Technical Bulletin

C521BEE

Product: DVD Player Hardware Technical Bulletin:C521BEE-H2005-04

Date: June 27/05 Subject: Laser ribbon cable

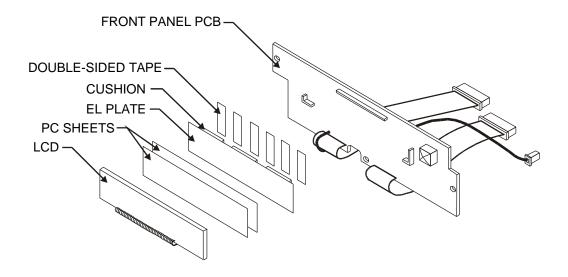
You may receive a complaint of the unit producing a very high whistle noise

The step up transformer for the display circuit is humming

- 1. Insert a transformer with more varnish impregnation
- 2. Apply glue to fix the step-up transformer to the main pcb
- 3. Add double sided tape between the cushion at the back of the EL display and the front panel pcb. Please refer to the drawing below

Figure 1

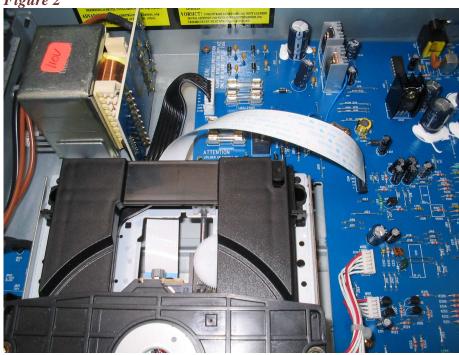
DESCRIPTION: You may have the complaint that some tracks skip or stops playing altogether.

REASON: The laser pick up connects to the main pc board via a flat ribbon cable and possibly is twisted the wrong way. It maybe getting caught on the fuse holders or other parts. just behind the transport mechanism. See figure 1.

SOLUTION: The ribbon cable needs to be allowed to wrap smoothly as shown in figure 2.
